Technical Journal

Oil leakage from plug in VVT pulley

REF NO:
TJ 29131.6.0

TJ Instruction VCC-475358-1

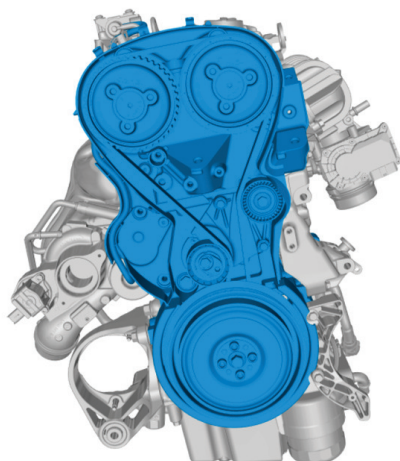
The oil may leak due to a crack in the plug from the VVT pulley (see attached photo).

Replace both plugs in both VVT-pulleys according to the attached instruction. Plug PN:31375877

Torque:
Plug VVT unit , 5 Nm

Note! Make sure that the component is clean, free of foreign material and lubricant.
